DVP's Proposed "Surry-Skiffes Creek Project" – Issues and Alternatives

Addendum Report

January 29, 2016

National Parks Conservation Association
777 Sixth Street, NW, Suite 700
Washington, DC 20001

Figure 2- PJM 2012 Forecast and PJM 2016 Forecast for DOM zone shows significant reductions in projected peak demand

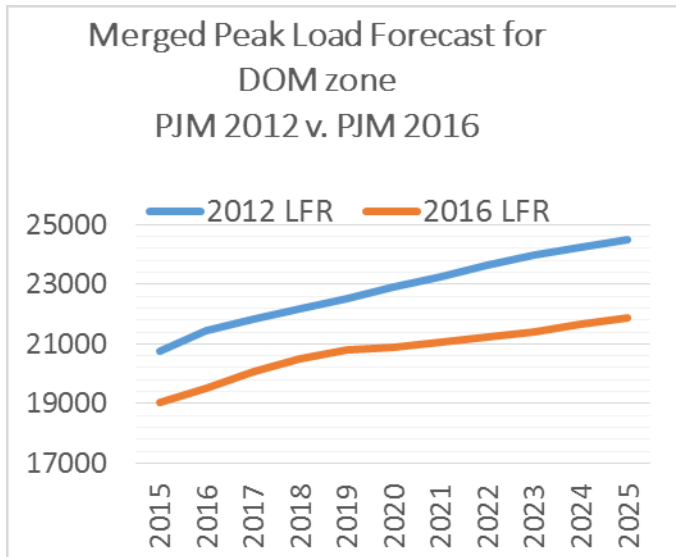
Error! Reference source not found. shows the forecasts from PJM 2012 and PJM 2016 on the same graph for ease of comparison. There are two striking differences: the new forecast is about 9 – 10

percent lower in 2015-2018, and the gap grows larger after 2019 due to reduced growth rates in the latest forecast. It should be noted that these trends do not include the reductions in peak load that could be achieved with more aggressive deployment of solar PV, DSM and efficiency.

Figure 3- Yorktown Output- Representative Samples, showing change in Yorktown operations since July 2013. In numerous cases, Yorktown Units 1 & 2 were not in operation yet no brownouts occurred.

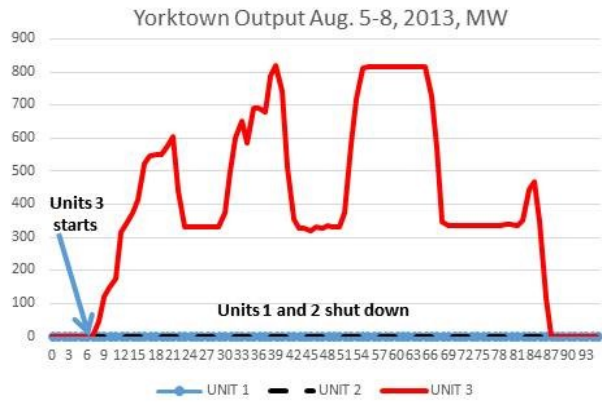
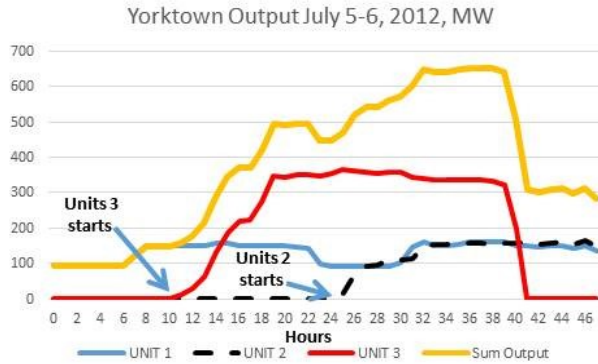
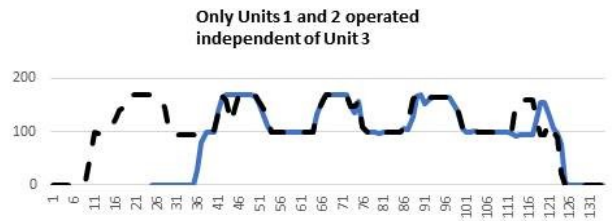
Figure 3 shows three sample graphs that illustrate this change. The vertical scale shows MW and the horizontal scale is the hour number of the event period. The first graph shows typical operation before July 2013 (July 5-6, 2012). The Unit 1 line (blue) is sometimes overlaid and obscured by the Unit 2 line (orange) since the units are often run in tandem. For this event and all of the first seven (out of thirteen) events, up until July 2013, all three units were used in concert. Units 1 and 2 follow a roughly bi-modal 24 hour cycle and Unit 3 mostly follows load during daily peaks, as illustrated in the first graph. For the four year analysis of peak summer season, Yorktown total generation reached or exceeded 1100 MW in

one event in August 2011 and one event in July 2013. Since then, it has never exceeded 840 MW in July or August (Unit 3 capacity).

The second graph shows typical solo operation of Unit 3 operations after July 2013 (August 5-8, 2013). Units 1 and 2 are cold (zero emissions) and Unit 3 (gray line) is operating solo. This event was a distinct change from past operational patterns. From this point forward, Unit 3 was operating solo during all of the remaining six events, up through August 2015.

The third graph shows a typical sample of Unit 1 and 2 operations after July 2013 (July 3-9, 2014). A comprehensive examination of operations of Units 1 and 2 showed that neither of them were running (zero emissions) within 48 hours of the start or ending of any of the six Unit 3-solo peak load events. Further, all periods were identified in July and August 2014 and 2015 when Unit 1 and/or Unit 2 were operating. These four periods are shown in the last four graphs in Appendix A. The data show that Unit 3 was not operating during these periods, and was not operating within 48 hours of either side (shoulder) of these periods. Since Units 1 and 2 need about 48 hours to warm up before taking significant load, the data contradict a DVP statement¹ that Units 1 and 2 are often needed as spinning reserves to support Unit 3 during the “shoulder periods” leading up to, and following closely after, peak events.

Figure 6- Possible James River Crossing Route for Buried/Submarine System

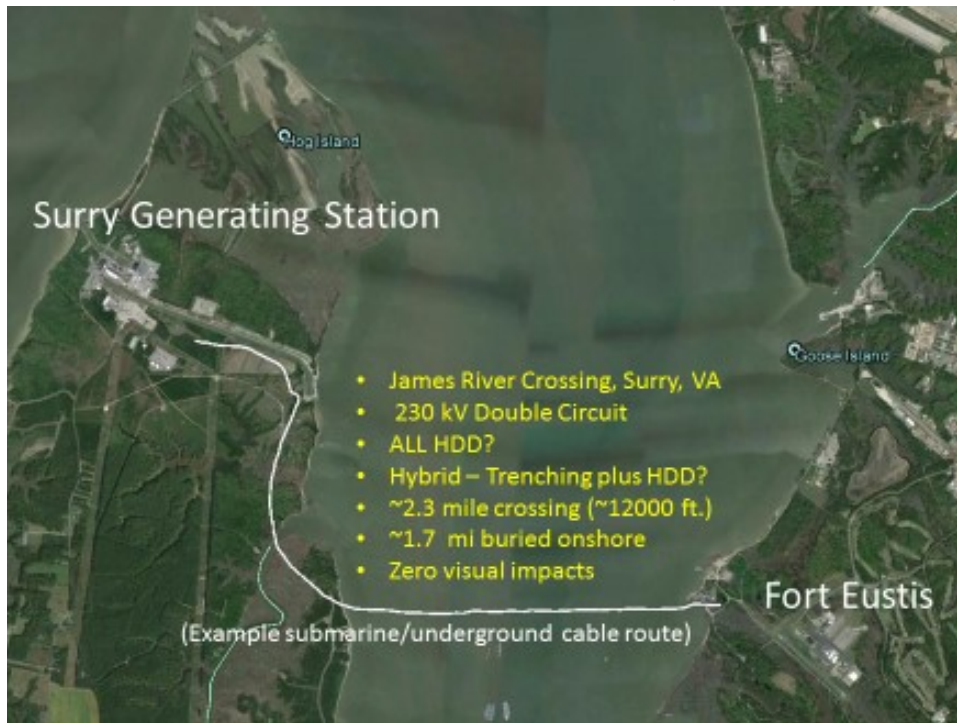
A potential lower cost river crossing option not yet fully analyzed could be connected at Fort Eustis. This is the narrow area of the river as shown in Figure 6. With recent advances in HDD, the entire crossing may be possible using that method, which reduces cost and impact compared to plow trenching across the river. The cable could also be undergrounded for the segment connecting to the Surry switching station. The eastern termination would be at Fort Eustis, a more secure location.
